**B&W NUCLEAR TECHNOLOGIES**

Enclosed are revised responses to 2 of the questions that were previously answered by B&W Fuel Company. The first response is to question 1 of reference 1 and was previously answered in reference 2. The second response is to question 8 of reference 3 and was previously answered in reference 4. The responses are being revised to reflect the results of telephone conversations that have taken place between the NRC, INEL, and BWFC.

Document Title: R56-LOCA B&W Loss-of-Coolant Accident  
Evaluation Model for Recirculating Steam

Figure 1-1 Test Vessel Inventory For UPTF Test 5 - Phase A<sup>1-3</sup>

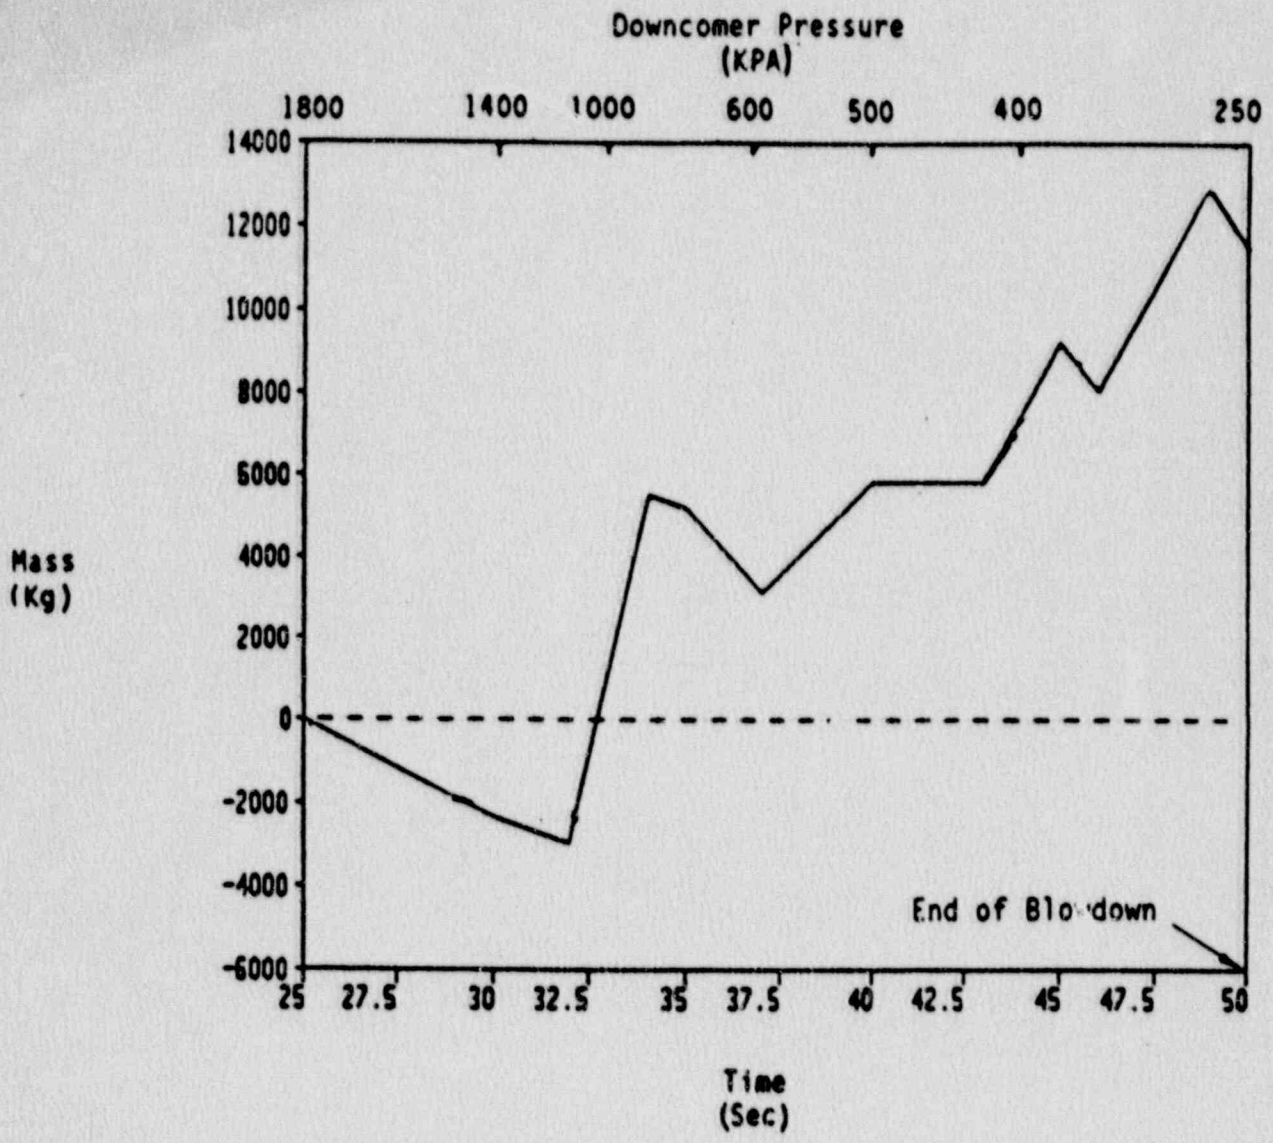
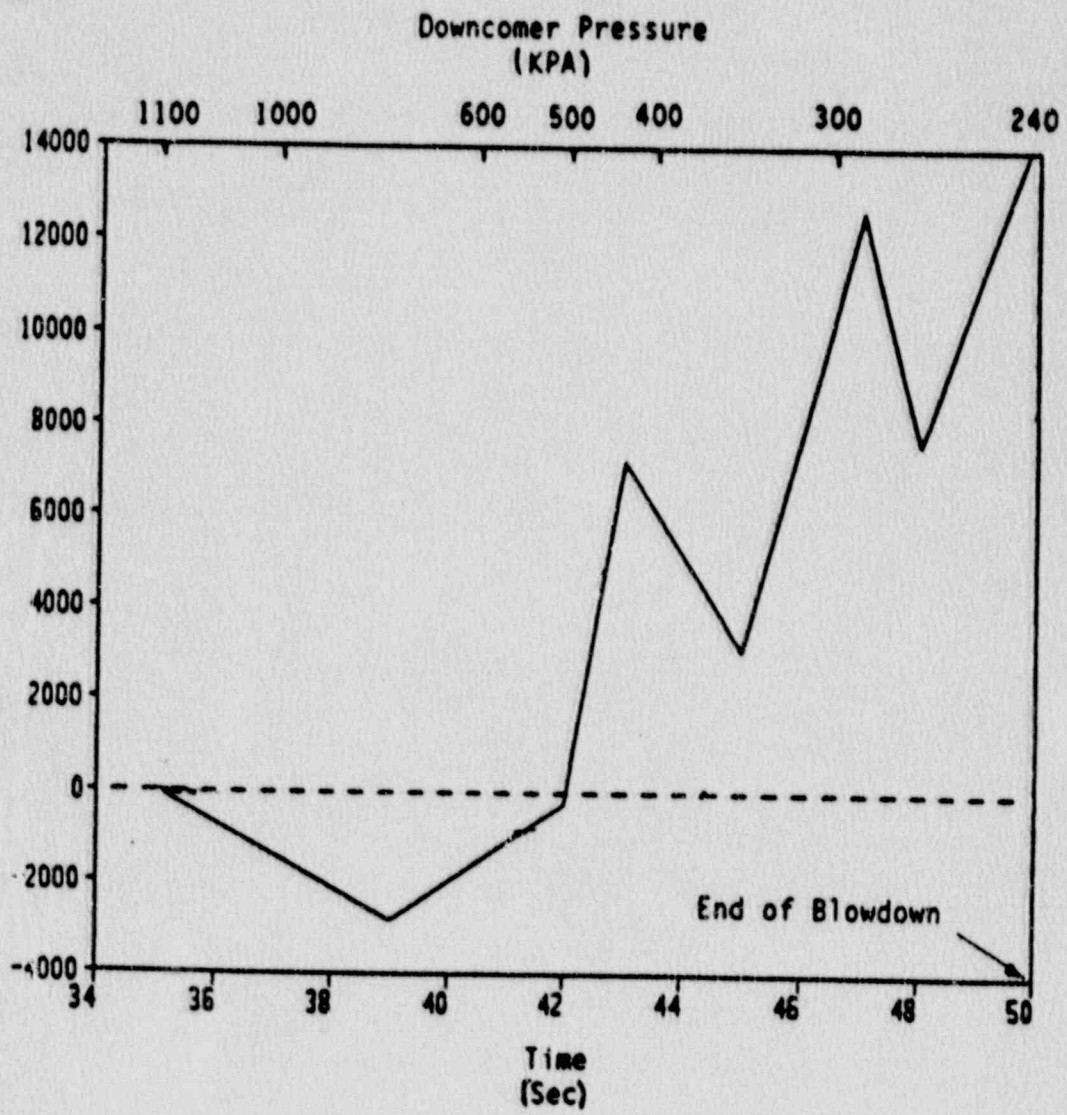
1. (a) Revision 1 of BAW-10168 stated that the ECC transport time, the time for the ECC to fall to the lower plenum once it enters the downcomer, is neglected based on Upper Plenum Test Facility (UPTF) Test No. 5. However, the UPTF data showed an approximately 2 second delay from the time the ECC entered the downcomer to the time the lower plenum collapsed level began to increase. Therefore, clarify your reasoning for neglecting the ECC transport time in the REFLOD3B analysis and discuss the specific data from UPTF Test No. 5 that supports your position.

Response: In Section 4.3.6.5 of the EM topical report BAW-10168 it is stated that the time required for ECCS water to pass from the reactor vessel inlet to the lower plenum is neglected and refill begins at the end of blowdown. The time delay was neglected based on the consideration that in reality bypass of the ECC water occurs at the broken cold leg nozzle, that when the flow at this nozzle is directed toward the reactor vessel bypass no longer occurs, and that ECC water in transit across the downcomer would, therefore, not be ejected from the reactor coolant system. The water in transit across the downcomer at the end of blowdown would fall into the lower plenum during the first several seconds of refill essentially eliminating the transit time delay in question. These observations are supported by UPTF test 5A. Figure 1-1, the test vessel inventory for test 5A, shows that partial ECC retention starts much earlier than the end of blowdown and full retention precedes the end of blowdown by several seconds. Figure 1-2 provides the inventory for UPTF test 4A and demonstrates the same effects. Both of these figures and the sequence of events for test 5A (refer to Table 3-1 of Reference 1.2)

Begin ECC injection	= 24 s (Plot time)
Begin Opening cold Leg Break	= 29 s
ECC Enters Downcomer	= 31 s
ECC Reaches Bottom of Downcomer	= 32.5 s

show a 1.5-second delay, in agreement with the question, from the first penetration of the downcomer until ECC water is observed in the lower parts of the test vessel. Under Revision 1 of the RSG LOCA evaluation model, that delay occurs as the ECCS first delivers water to the reactor vessel and should not be repeated during refill.
